<b>TAL-CO SUPPLEMENTAL INSTRUCTION #73</b>			
<b>REVISED FLOOR 2 EXEC OFFICE LAYOUT - 225A &amp; 225B</b>			
Project Name:	<b>RW TOMLINSON - NEW HEAD OFFICE</b>		
Project Location:	<b>100 CitiGate Drive, Ottawa, Ontario</b>		
ARCH. SI #:	<b>ASK'S 210, 211 &amp; 212</b>	Issued By:	<b>Farah Bano</b>
STRUC. SI #:	<b>N/A</b>	Date Issued:	<b>December 1, 2017</b>
MECH. SI #:	<b>N/A</b>	Revision #:	<b>N/A</b>
ELEC. SI #:	<b>N/A</b>	Revision Date:	<b>N/A</b>

**TITLE: REVISED FLOOR 2 EXEC OFFICE LAYOUT - 225A & 225B**

PROJECT:  
**TOMLINSON NEW BUILDING**

**ASK-211**

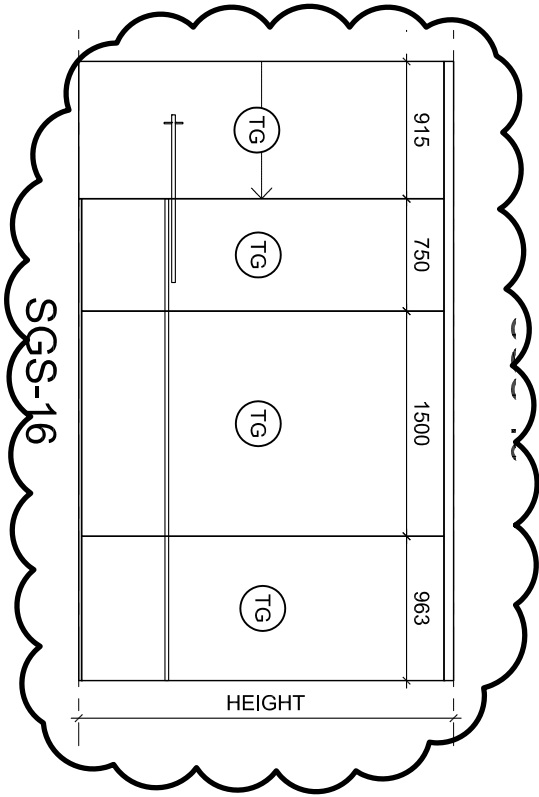
Previous Office 225 layout revised to create two separate offices 225A & 225B. Please review for any changes required on your end. Changes include but are not limited to drywall/ glass partition / ductwork / fire safety / flooring / signage requirements.
